The Keadby 3 Low Carbon Gas Power Station Project

The Keadby 3 (Carbon Capture Equipped Gas Fired Generating Station) Order

Environmental Statement Volume II - Appendix 10B: Road Safety Audit Report Stage 1

- 1.1.2 This Stage 1 Road Safety Audit (RSA) has been carried out on the proposed design of the proposed access to the Proposed Development from the A18, in Belton, near Scunthorpe.

IMAGE: Extract from Drg: 60625943-ACM-XX-XX-DR-D-0000-001 showing existing RRS

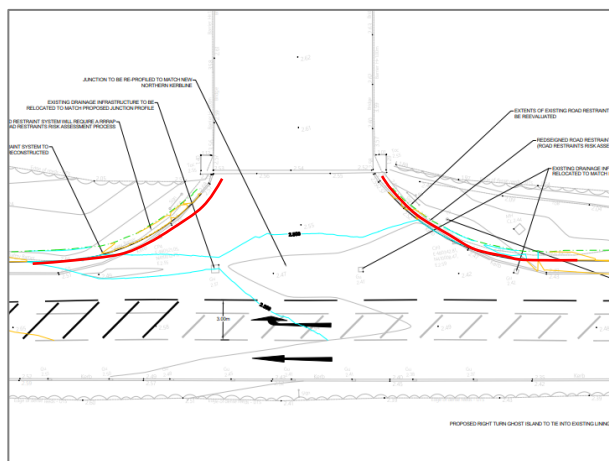
Problem:	4.1.1.
Location:	A18 junction with existing Keadby 2 Construction Access.
Drawing:	60625943-ACM-XX-XX-DR-D-0000-001.
Summary:	Risk of single vehicle loss of control collisions and increased severity as a result of inadequate Road Restraint System (RRS).

The A18 junction with the main Keadby 2 Construction Access has an existing Road Restraint System (RRS) on both the east and westbound approaches, protecting errant vehicles from entering the adjacent Hatfield Waste Drain and/ or coming into contact with the bridge structure.

The general arrangement drawing provided to the Audit Team states that the existing RRS is proposed to be redesigned and a Road Restraint Risk Assessment Process (RRRAP) assessment undertaken, however this information has not been provided to the Audit Team.

The Audit Team has concerns that should the incorrect RRS design be implemented, there may be an increased risk of errant vehicles entering the adjacent Hatfield Waste Drain and/ or coming into contact with the bridge structure increasing the severity of the collision and injuries.

It is recommended that a RRRAP assessment is undertaken and the existing RRS is fully replaced.

IMAGE: Extract from Drg: 60625943-ACM-XX-XX-DR-D-0000-001 showing proposed road marking design

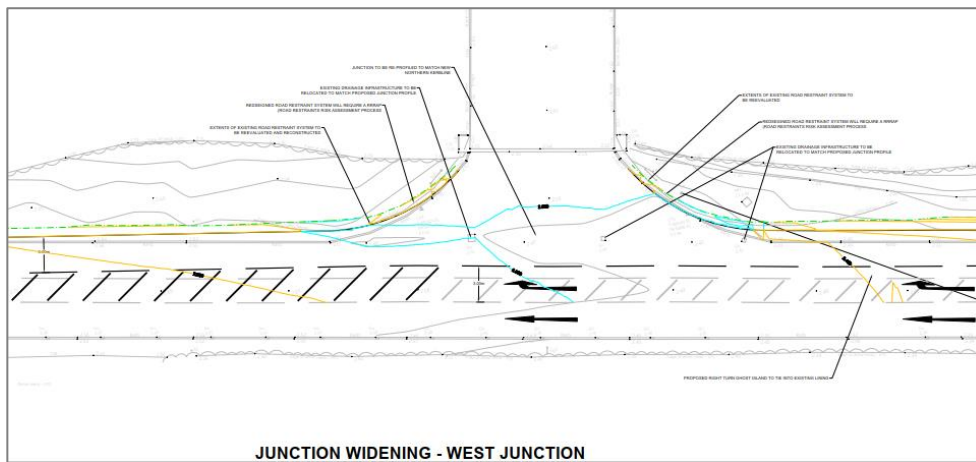
Problem:	4.4.1.
Location:	A18.
Drawing:	60625943-ACM-XX-XX-DR-D-0000-001.
Summary:	Risk of rear shunt and/ or head on type collisions as a result of proposed road marking design.

During the site inspection the Audit Team observed a number of vehicles that appeared to be travelling at high speeds along the A18, occupying the central ghost island and opposing lane to overtake other vehicles.

The proposed works include a right turn pocket within the existing ghost island, providing an area for right turning vehicles entering Keadby 3 to wait.

The Audit Team has concerns that the proposed road marking design will not prohibit vehicles over taking on the approaches to the proposed right turn pocket, potentially increasing the risk of rear shunt and/ or head on type collisions.

It is recommended that solid white line road markings to Diag 1013.1 and 1013.3 are provided on the approaches to the proposed right turn pocket and/ or provide traffic islands and associated island to protect the right turn pocket.
